Diagrams between Artesia and Grant

The mess of pipelines and embankments in Redondo
(after 1 diagram of set-up in Lawndale)

Figure 2.3-18. Trench Option – Looking South of Artesia Boulevard Modified to show current conditions

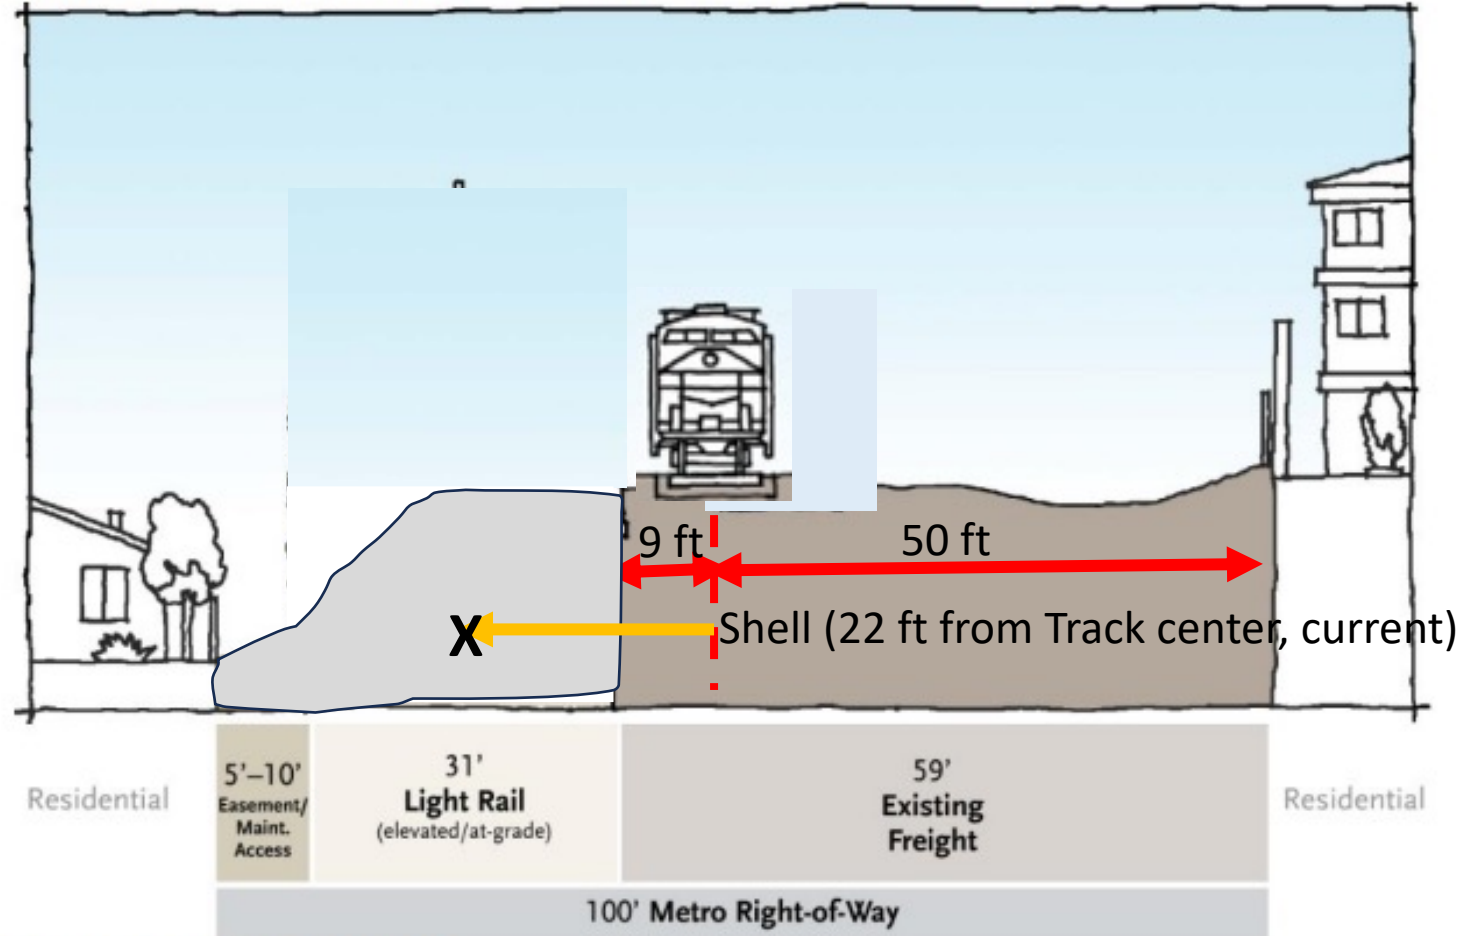
- I have just shown the same Shell pipeline on the eastern edge. **Position is the X**; pipeline runs into the paper. (Crimson pipeline not shown)
- Depth below surface is not indicated
- “Flat part” of ROW is only about 80 ft wide here.

Figure 2.3-18. Trench Option – Looking South of Artesia Boulevard

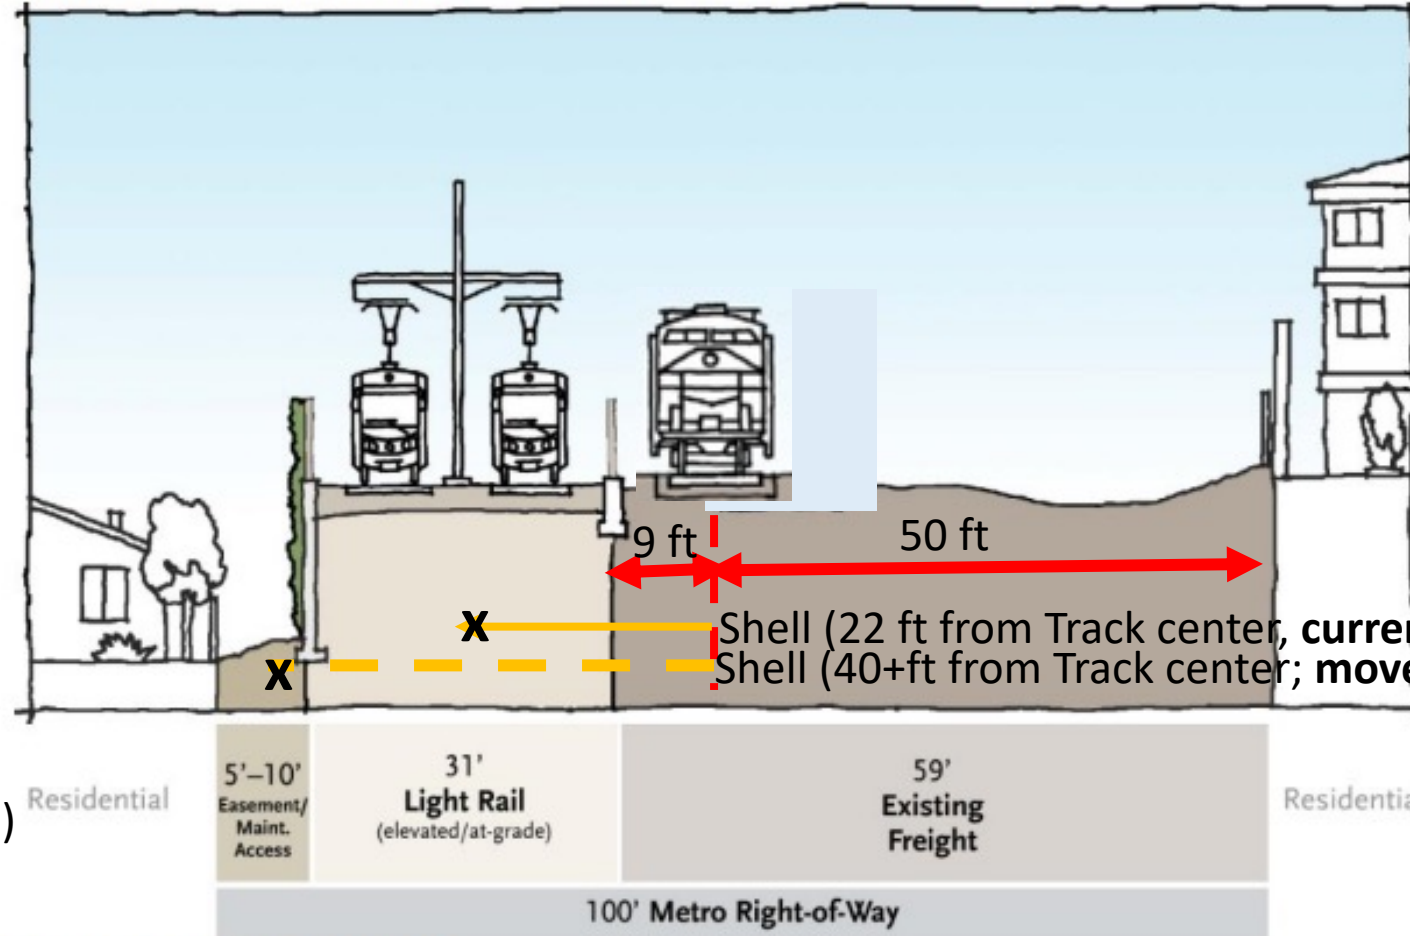
CHANGES REQUIRED;

- *Fill in embankment
- *Build **huge massive** wall
- *Bury the pipe deeper; mere steps from (or into) people's back yards.

This could cause damage to foundations, just as it did on the western side of the ROW, back in 2020 when a pipeline was repaired. (Refer back to big red dot a few pages back.)

Shell (22 ft from Track center, **current**)
 Shell (40+ft from Track center; **moved; and buried deeper.**)
